Technical Service Information

THM 3T40 (125C) GOVERNOR SCREEN ADDED

Figure 1

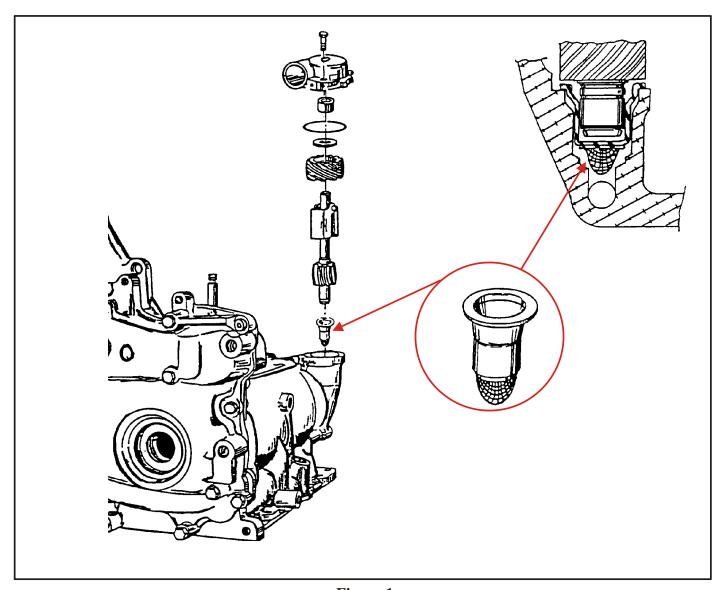
The governor screen was added (1986 Julian Date 203) to the governor sleeve in the case, to minimize the possibility of sediment entering the governor assembly and preventing the governor balls from seating properly (See Figure 1).

A machining change was needed in the case to make room for the new governor screen, thus it will not retro-fit to previous models.
